#### **Grant Alternative School**

#### **Building Analysis and Review of the Visual (Cost & Picture) Report**

Photos of the re-corded boilers

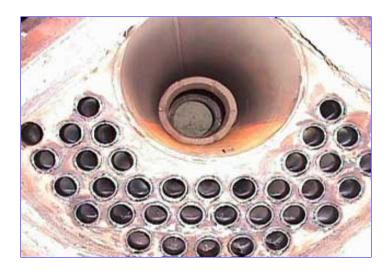
The boilers have been re-cored this summer and appear to be in fine condition. The steam and hot water radiation system should last for many years if the water is conditioned properly. All piping and radiators reviewed appear in good condition.

The existing boilers have just been re-corded

Concrete repairs required for the southeast stair

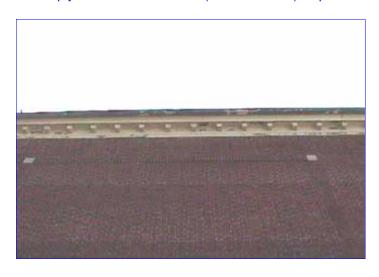
- No monies outlined for asbestos abatement.
- No note for any exterior painting.
- The rainwater gutters and downspouts require review and repair.
- The rear eastern stair of the main building is badly spalled and posses a safety hazard.
- Some of the face brick on the main building have spalled and should be re-pointed as soon as possible to prevent further damage to the exterior skin.

The spalled concrete is a safety hazard
